Bid Bulletin #02

PROJECT: Gateway Early Childhood Center
Bid Package #4
Omaha, NE

ADDENDUM E

Gateway Early Childhood Center
Omaha, Nebraska
RDG Project No. 2014.129.00, File 35.1

ADD ALTERNATE 19: UNDER THIS ALTERNATE, PROVIDE BRICK STEPPING AS INDICATED IN DETAIL B1 / A05.03 IN ADDITION TO PROVIDING BRICK COLORS AND BLENDS AS INDICATED ON BRICK BANDING ELEVATIONS (A2, B2, C4, & D4 / A05.03).

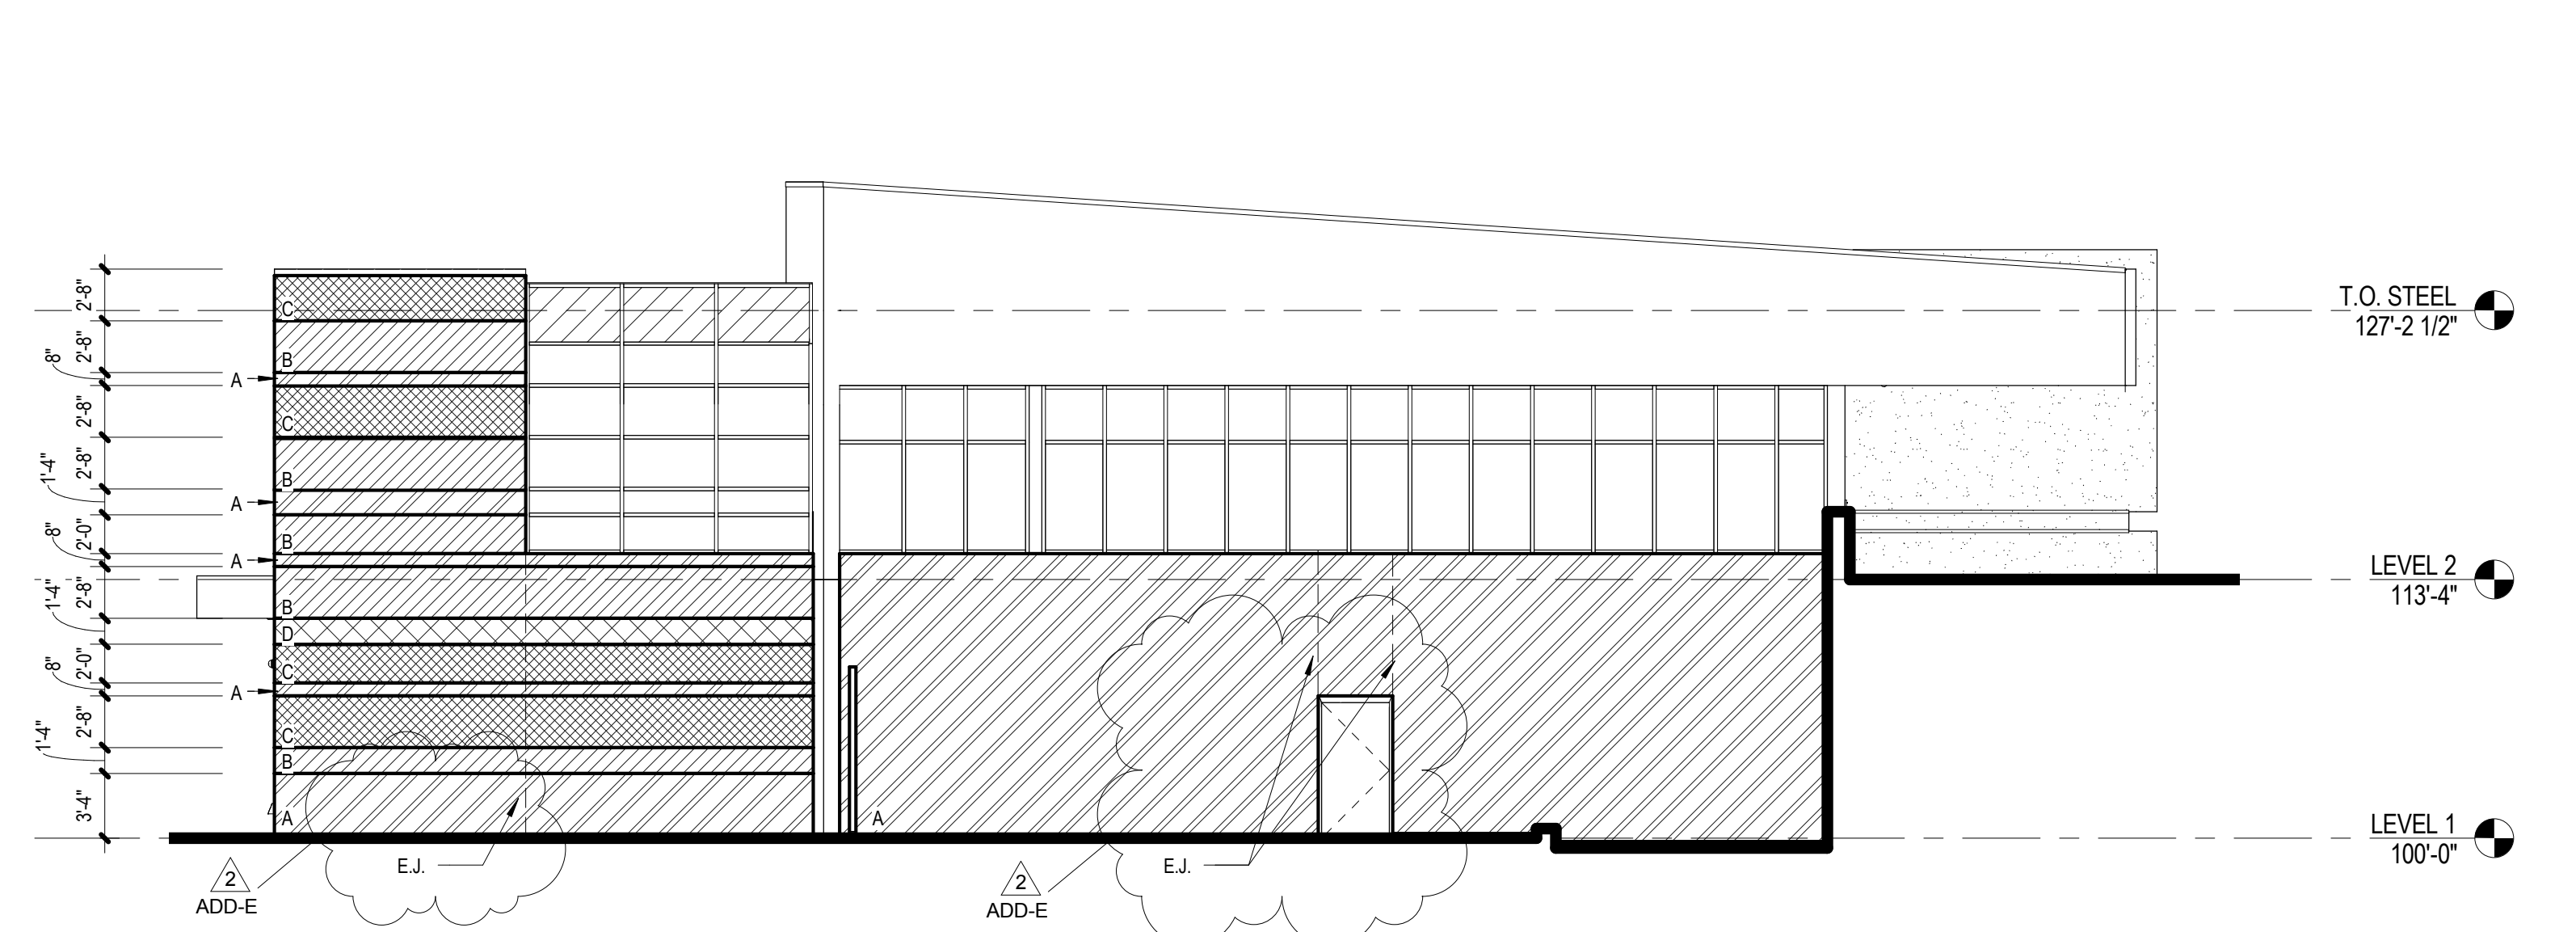
- A. A2 – “South Elevation:” Brick veneer expansion joints indicated.
- B. B1 – “Stepped Brick Rules:” Add “Brick Stepping Summary” as shown to clarify brick stepping. Modify note at window head as shown to clarify that the single course of Color 1 brick should not extend beyond window head conditions.
- C. B2 – “North Elevation:” Brick veneer expansion joints indicated. Add typical note indicating brick at head conditions for both Base Bid and Alternate 19.
- D. C4 – “East Elevation:” Brick veneer expansion joints indicated.
- E. Brick Banding Legend: Update type designations to clarify base bid brick stepping.
